MEMO

From: Robert Montgomery (Independent DA Assessor)

Subject: 2017SNH069 - Lane Cove – DA117/2017

Lane Cove LEP 2009 Revised Clause 4.6 Exceptions to Development Standards – Height of Building

Figure 1: Extract from Lane Cove Bushfire Prone Land Map

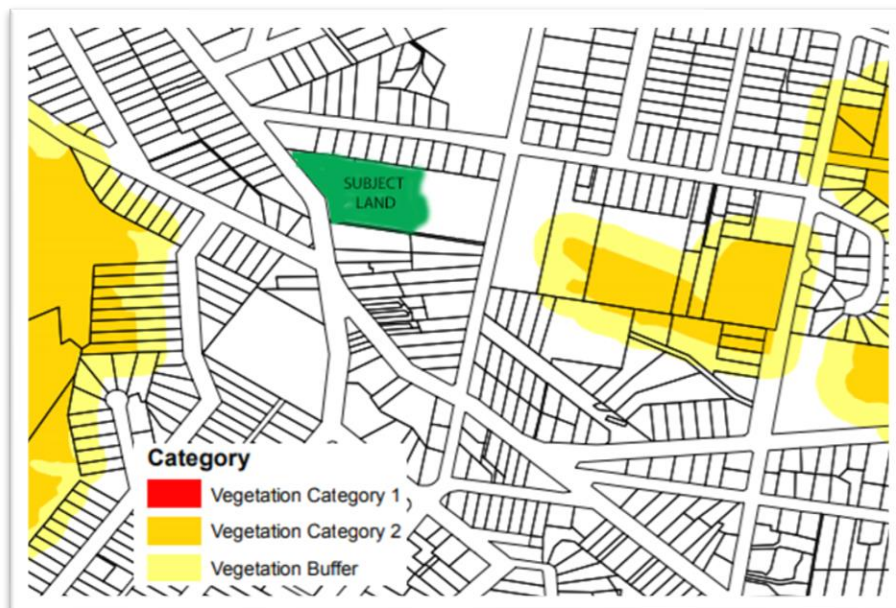
Figure 1 below is an extract from the Bushfire Prone land map which confirms that the subject site is not identified as bushfire prone land.

The eastern boundary of the site is located some 125 metres from land which is identified as bushfire prone. Therefore subclause 1 does not apply. Based on the proximity to bushfire prone land, it is reasonable to draw the conclusion that the land is “in the vicinity of land identified as bushfire prone” as mentioned in subclause 2.

Figure 2: Level 7 Floor Plan Showing Units and Services

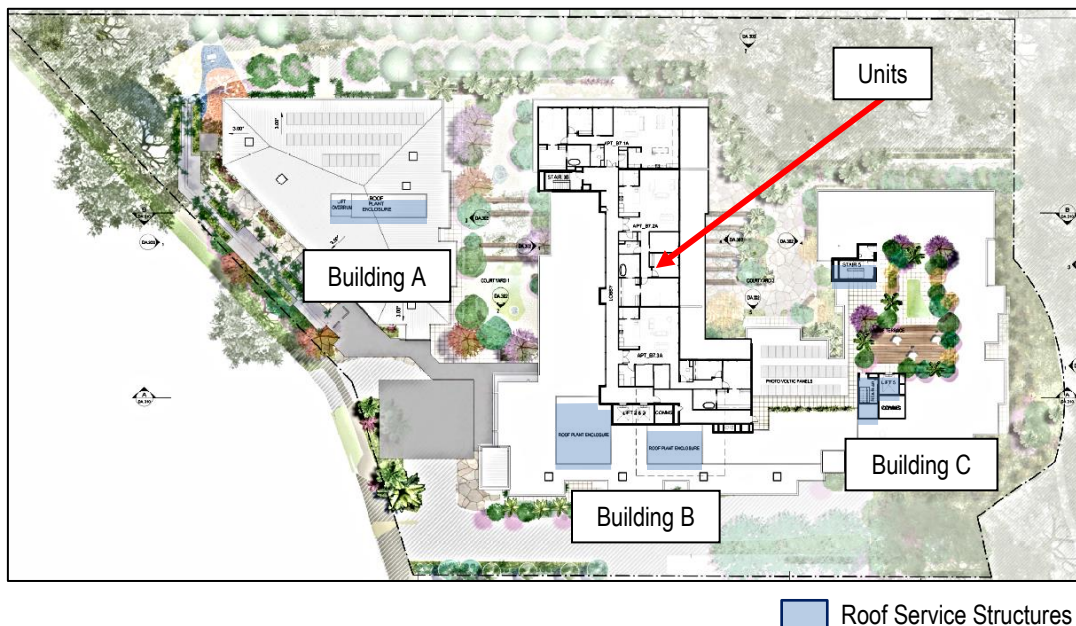
The lift overruns and stairs servicing the respective buildings are the highest points of the development. However, these are setback from both the property boundaries and from the leading edge of the buildings (see Figure 2). It is noted that the centrally located rooftop landscaped courtyard is also located above the height limit. The location of some of the roof structures have been altered since the DA design.

Three 2 bedroom units are proposed on Level 7 which is proposed at the top of Building B. This level will have a maximum pitched roof height of RL 67.01, which is 4.21m over the height limit (see Figure 2).

As indicated in Figure 2, the structures are relatively small and are not considered to result in adverse environmental impacts.

Figure 3: Shadow Diagrams Showing impact on the Public Domain

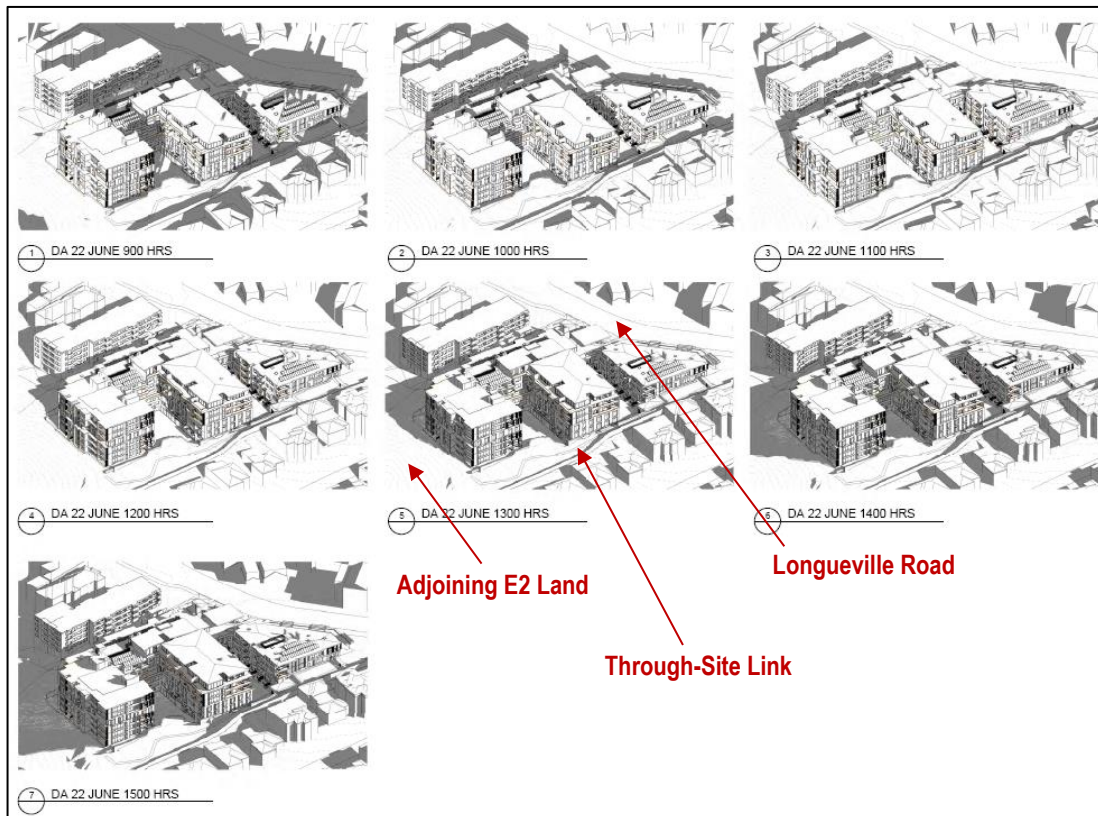
There are three areas within and around the subject site that would be considered as public domain: Longueville Road to the west, the E2 zoned land to the east, and the proposed through site link within the northern setback of the development. Given the orientation of the subject site, the proposal will not result in significant overshadowing to the public domain areas identified. This is demonstrated in the 3D shadow diagrams prepared by Thomson Adsett and submitted separately (see Figure 3 on the following page)

The proposal presents as two storeys to Longueville Road, which will maximise sunlight at the street frontage. In order to further improve solar access to Longueville Road, a reduction in the number of storeys at the street front (Building A) was considered. This would not result in a good planning outcome, as it would create a single storey presentation to Longueville Road. This is inconsistent with the adjoining Timbertops development, as well as other two storey built forms in the street. A reduction in the non-compliant lift shaft to Building A was also considered. However, as the lift shaft is set back from the front building line, its reduction would not affect the extent of solar access to Longueville Road.
